APPEAL SUMMARY

Appeal ID: 22155

Building/Business Name: Parkview at Terwilliger Plaza

APPEAL INFORMATION SHEET

Appeal 01 Item 02 Exhibit A

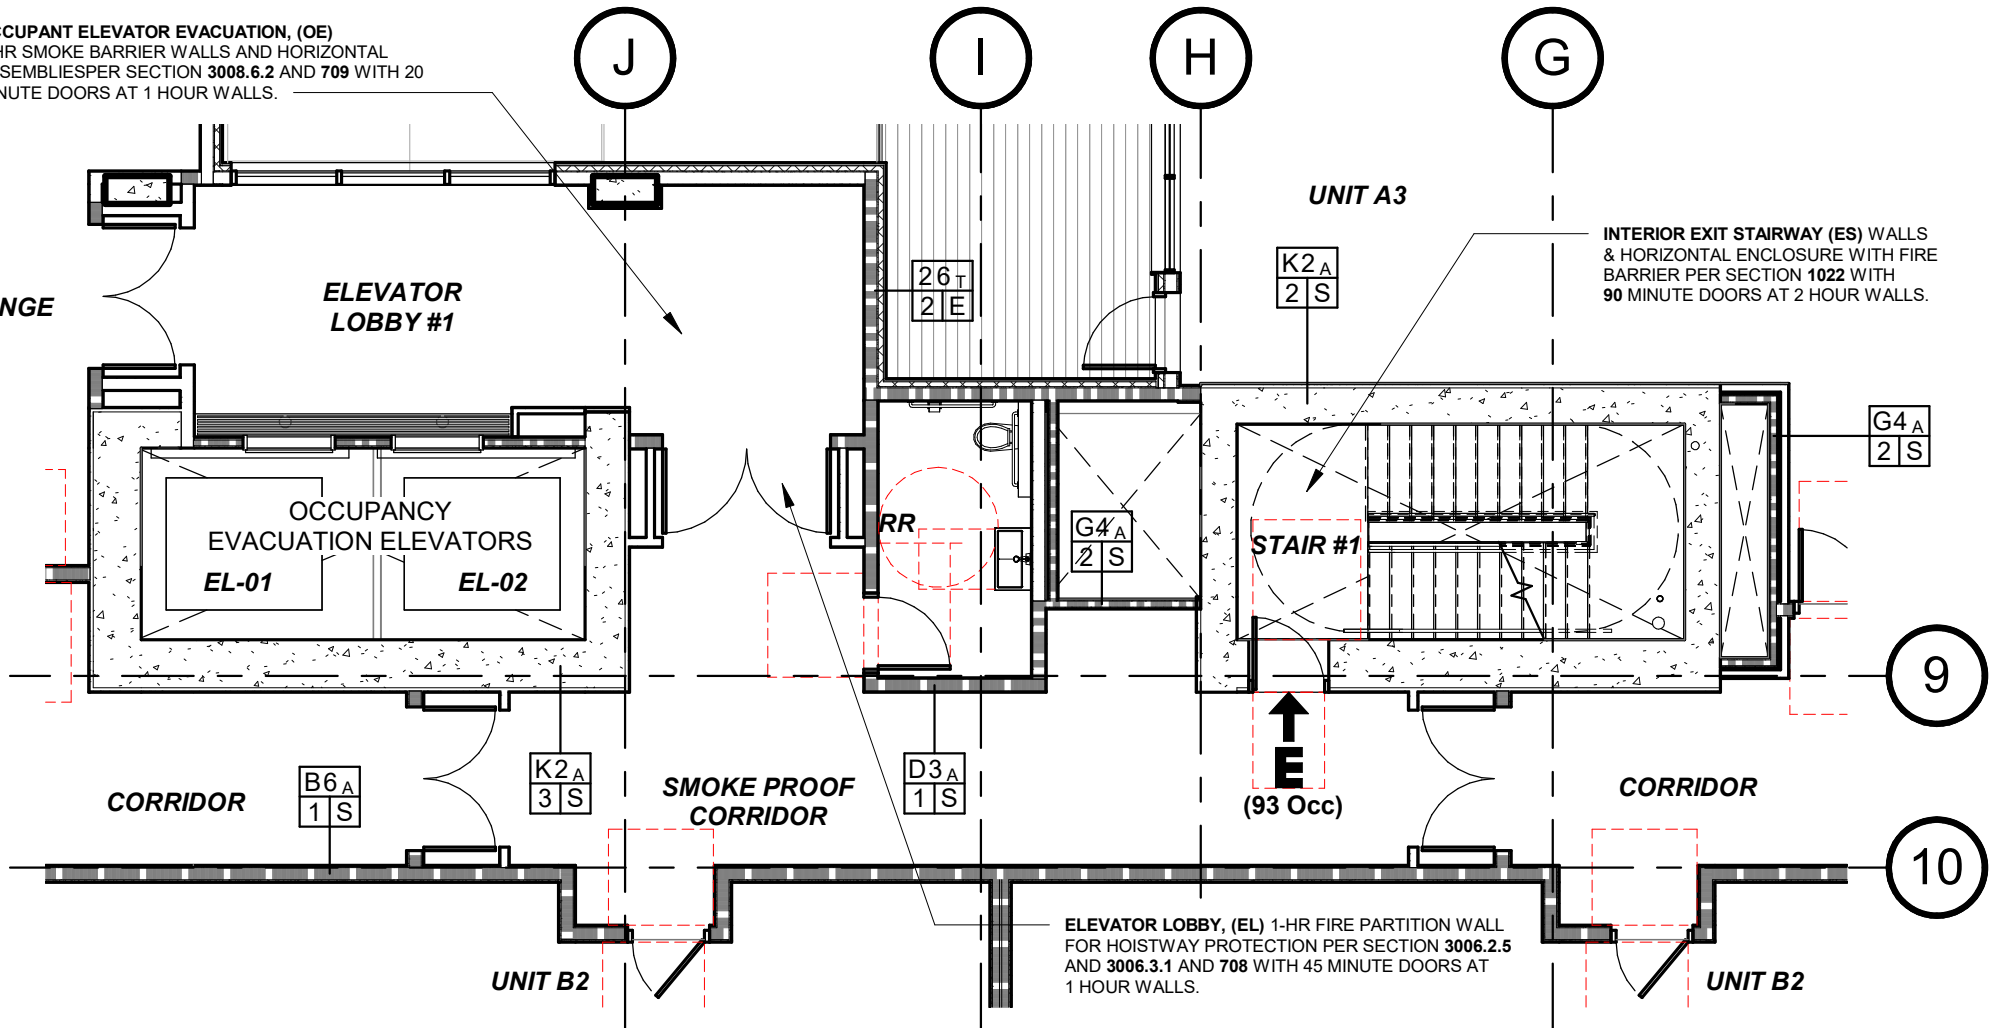
Proposed Design The occupant evacuation elevators are connected to the egress stair component (Stair #1) from the Roof Level to Level 1 which is the level of discharge to the public right of way. For the R-2 occupancy portion of Level P2 with residential units, we have provided two (2) direct exits to the public way. Portion of Level 2 and Level P3 are S-2 occupancy providing parking only, therefore no connection from the elevator to the stair will be provided. An Area of Refuge is provided within the elevator lobby enclosure meeting requirements with Section 3008.6.1 through 3008.6.6 which includes a two-way communication system in case of emergency.

Reason for alternative Project is voluntarily electing to provide the occupant evacuation elevator component as an additional safety measure for the special considerations of the age and abilities of the R-2 building residents.

The building height is 107'-6" above the lowest level of fire department vehicle access (on 5th and Sheridan corner) so occupant evacuation elevator requirements are not required per 403.6.1.

The elevator lobby meets the requirements of 3008.6.1 through 3008.6.6.

2. Omission of direct access from the occupant evacuation elevator lobby to the interior exit stairway:

Granted as proposed.

Appeal 01 Item 02 Exhibit B

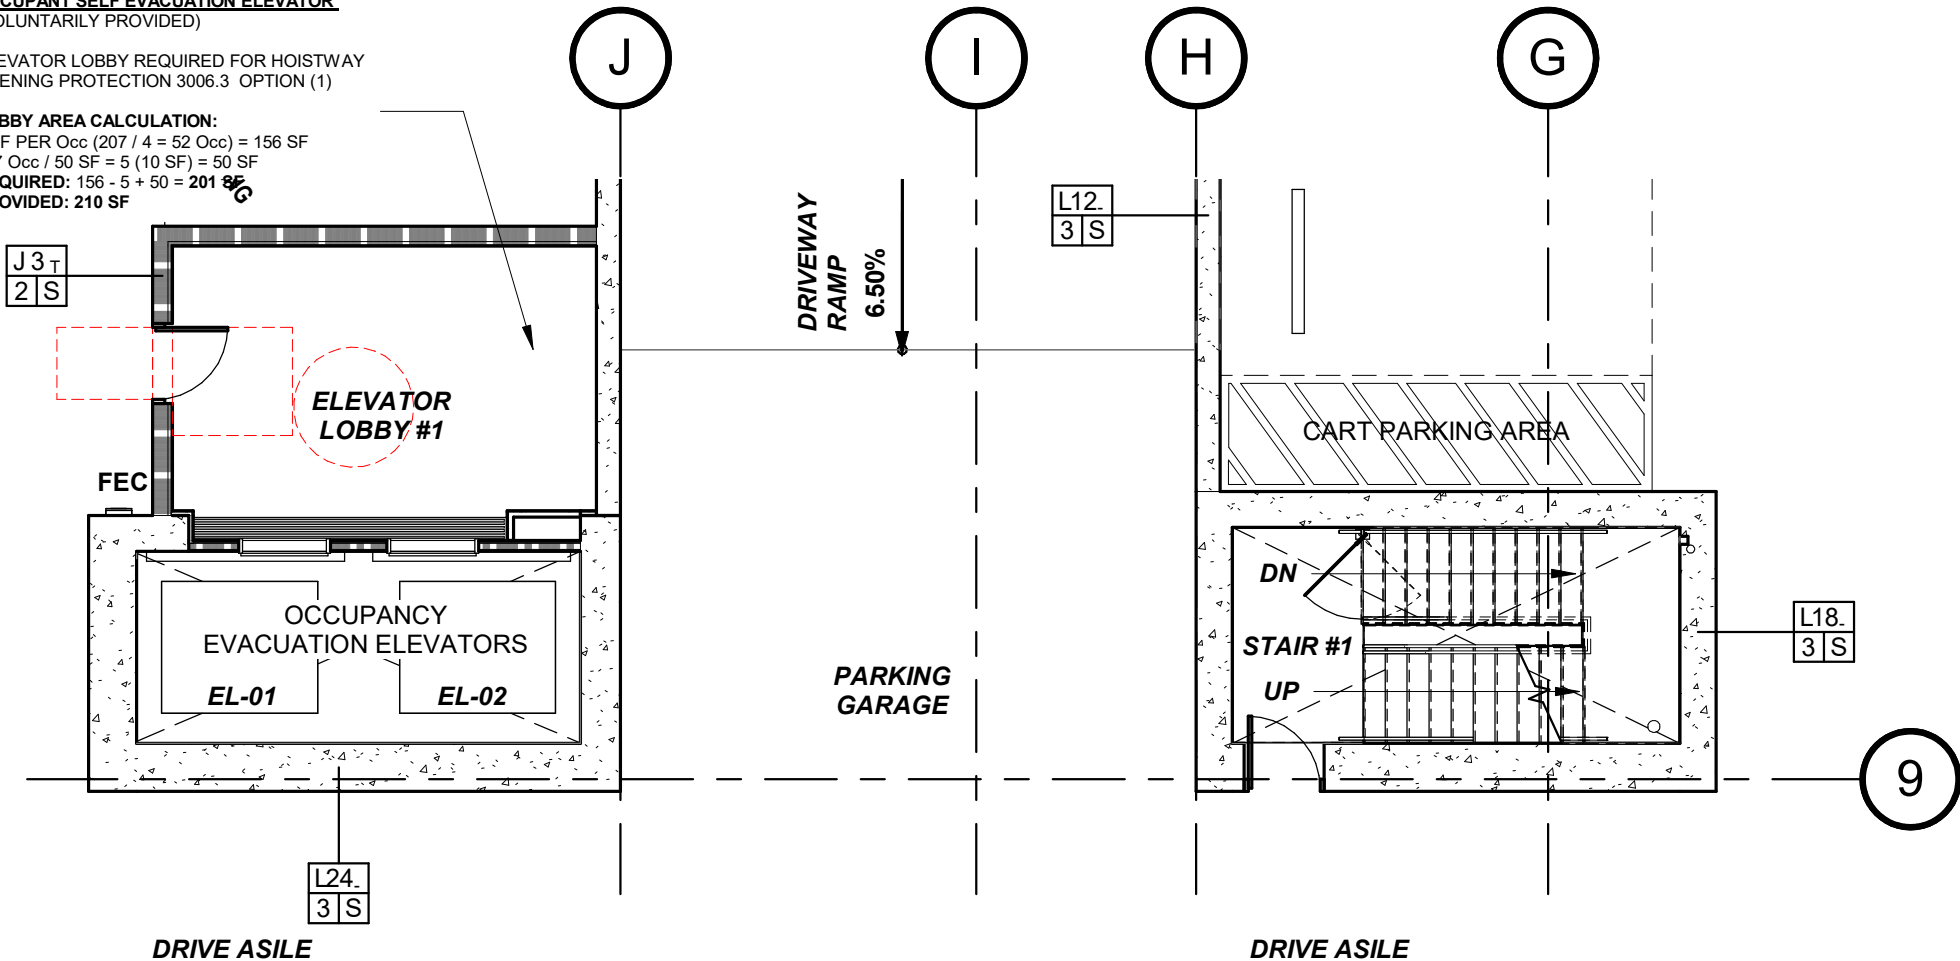
On the lowest levels the lobby is provided with a 2-way communication system and are sized to the area of refuge required to be a safe waiting area until help comes.

Appeal 01 Item 04 Exhibit A

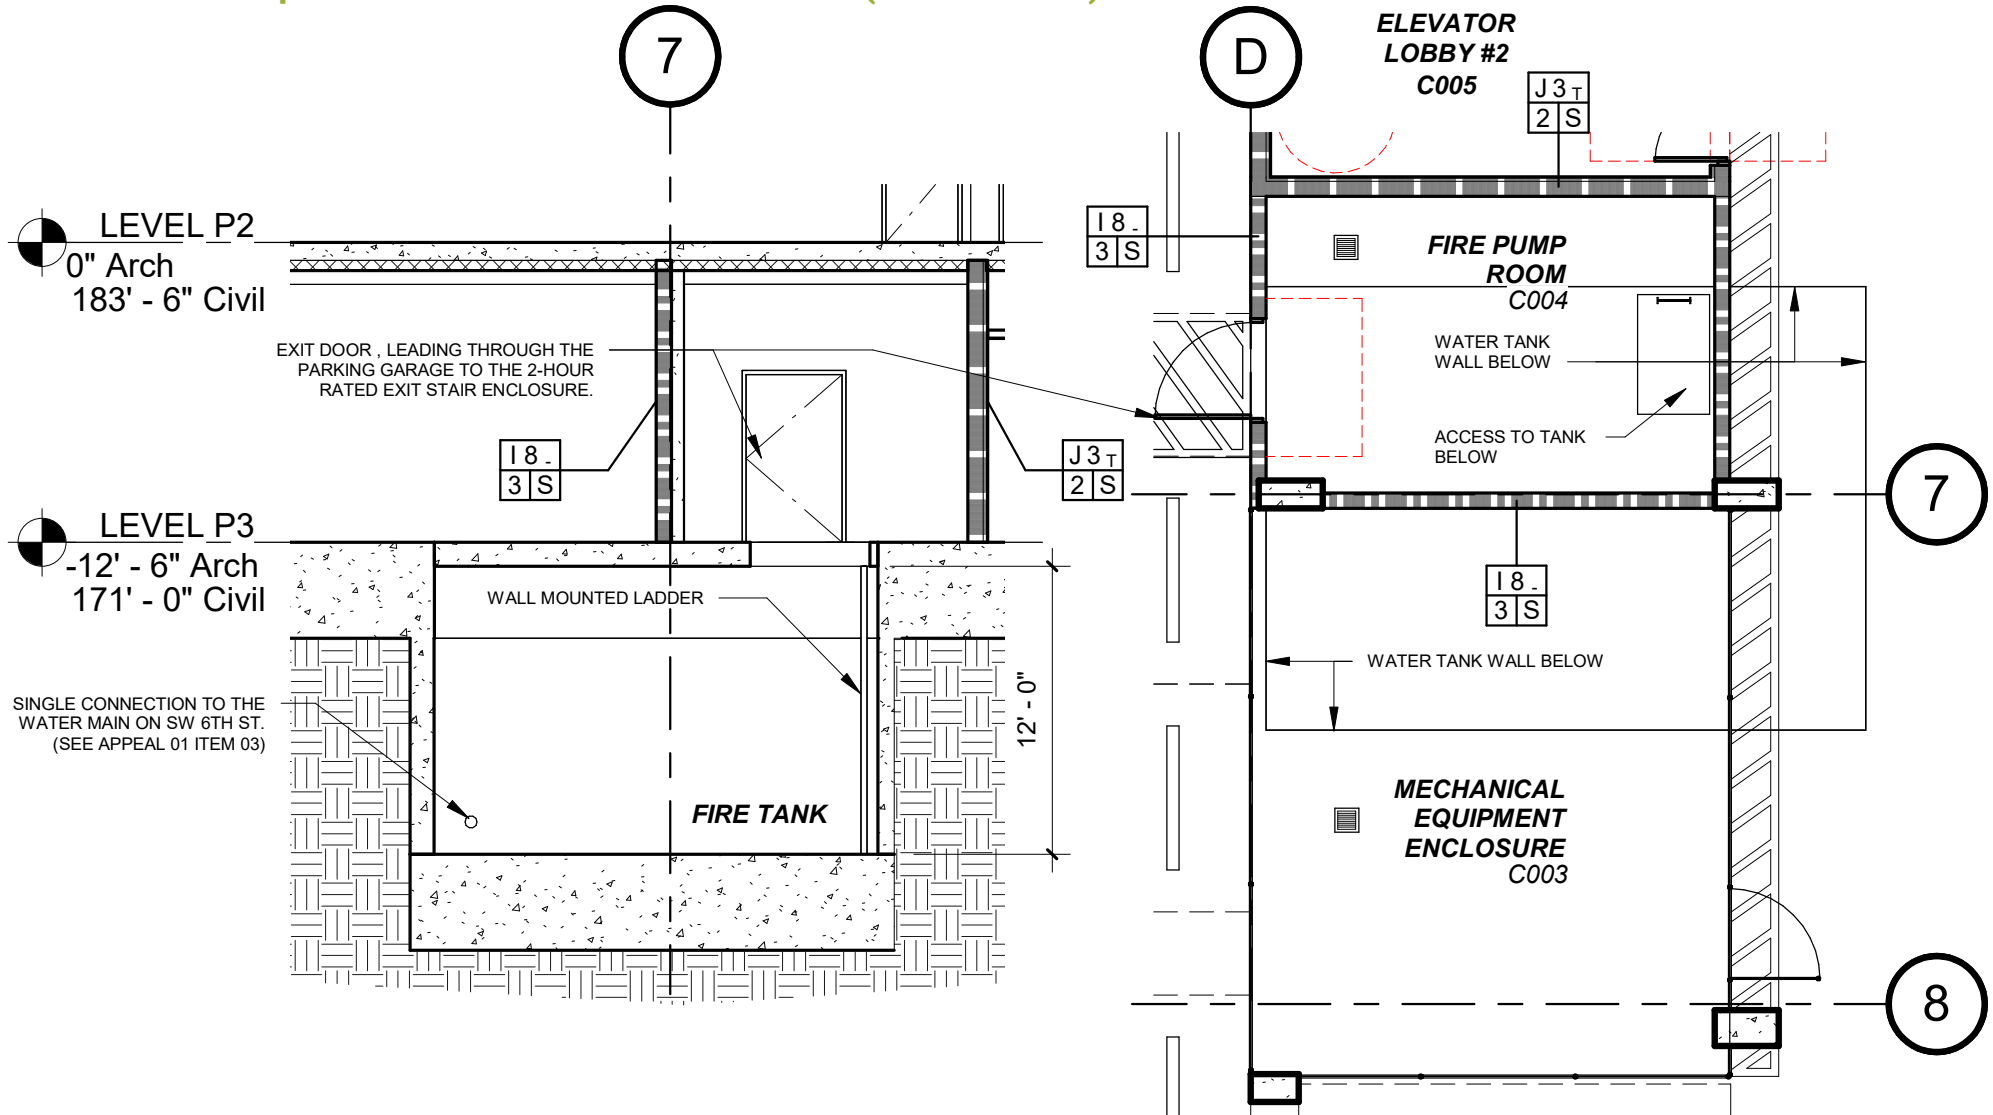
Proposed Design The proposed design is an 9-story Independent Senior living high-rise building, of Type I-A construction, the building will be equipped throughout with an automatic sprinkler system. The fire pump room is located at Garage level P3. The proposed design does not provide a continuous rated direct connection to an interior exit stairway.

The fire pump room enclosure is 3-hour rated, located within a 2-hour rated parking enclosure and the nearest exit stair enclosure is 2-hour rated.

The path of travel between the fire pump room and the enclosed exit stairway measures 78 feet in length and will have OH2 sprinklers along the route from the stair to the pump room.

Reason for alternative The fire pump room will be provided with more protection than required by code. Since the building is sprinklered and a high-rise, the pump room is only required to be 2-hour rated, but the proposed design provides a 3-hour pump room enclosure.

Access from the pump room to the exterior is through a 2-hour rated stair enclosure, and a clearly posted directional stair signage in the direct sightline from the fire pump room door. Clear signage will be provided at the pump room and the stair enclosure. This pathway will be protected with the higher OH2 density sprinklers, which provides additional protection to the required OH1 sprinklers for the parking garage.

This path is within the Type I-A concrete parking garage, and measures 78 feet from door to door. In essence, this fire pump room is 3 hours rated sitting in a 2-hour rated larger box [the parking garage] that is also fire sprinklered.

4. Omission of 2 hour fire rated passageway connecting fire pump room to exit: Granted as proposed.

Appeal 01 Item 05 Exhibit A

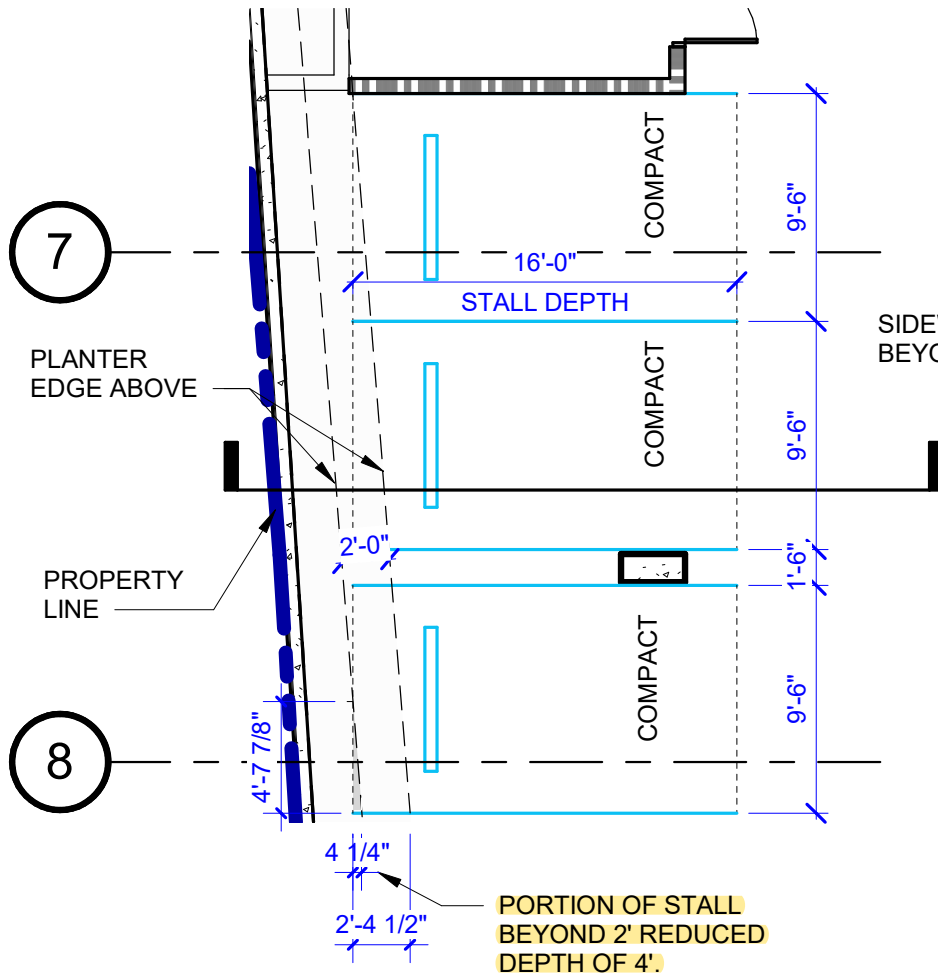
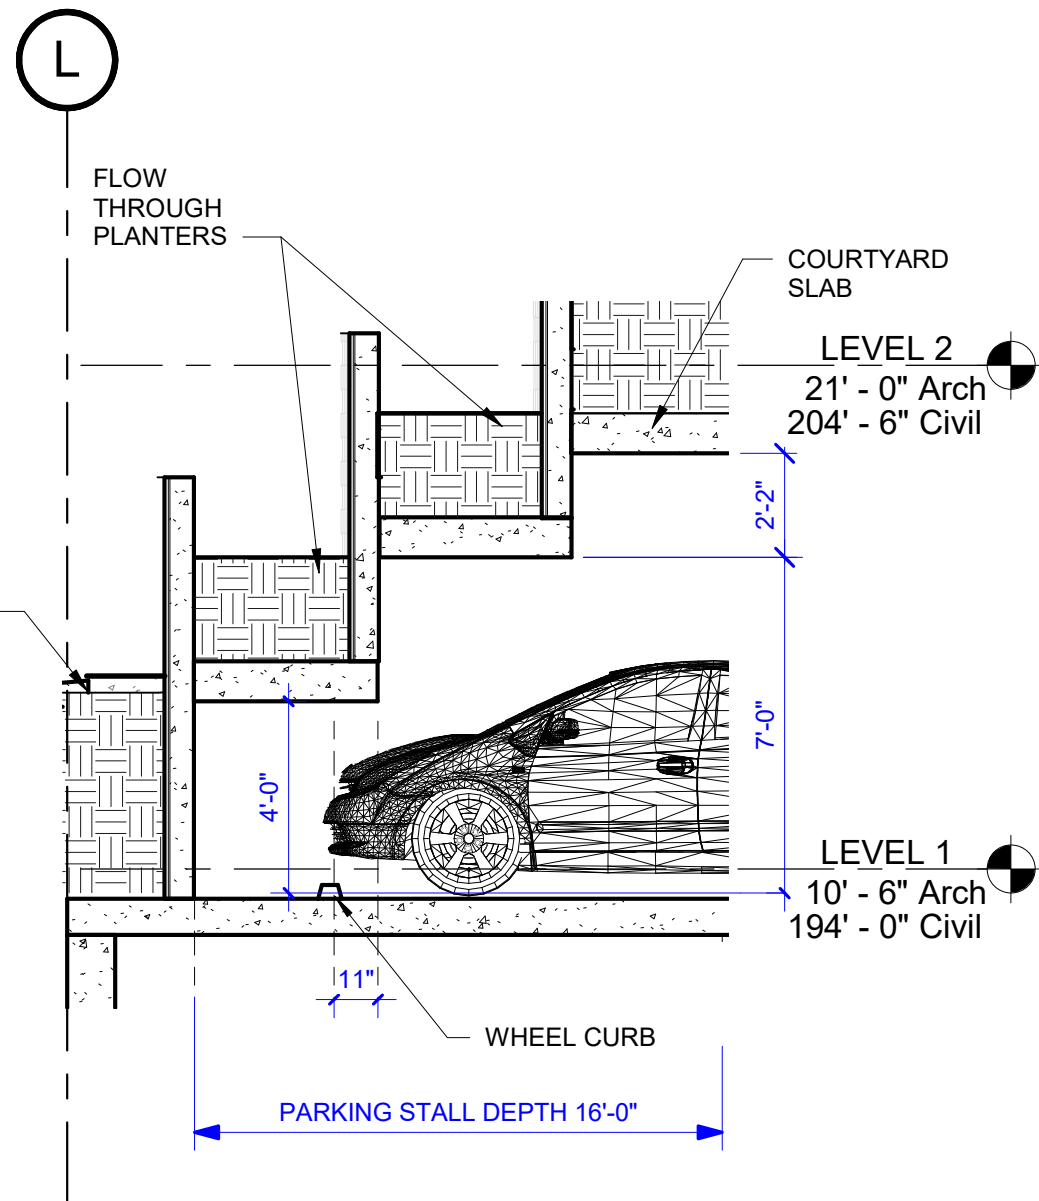
Proposed Design There are 3 compact parking stalls out of 172 stalls that have reduced head height at the nosing. The reduction is not caused by the allowed shelving, storage surface, cabinet, piping or duct work, but rather a concrete flow through planter that protrude into their spaces 24" max. and head height reduced to 48" minimum.

One (1) of these 3 stalls has a 4'-1/4" by 4'-6 1/4" triangle (0.81 square feet) of nosing in additional to the 24" stated above with height reduced to 4' see hatched area in the attached sketches.

Reason for alternative The project is providing a flow through planter that need to be lower than the courtyard level to serve the courtyard storm water management system which will protrude into their spaces with 24"

5. Reduction in headroom at 3 parking stalls to minimum 4 feet: Granted as proposed.
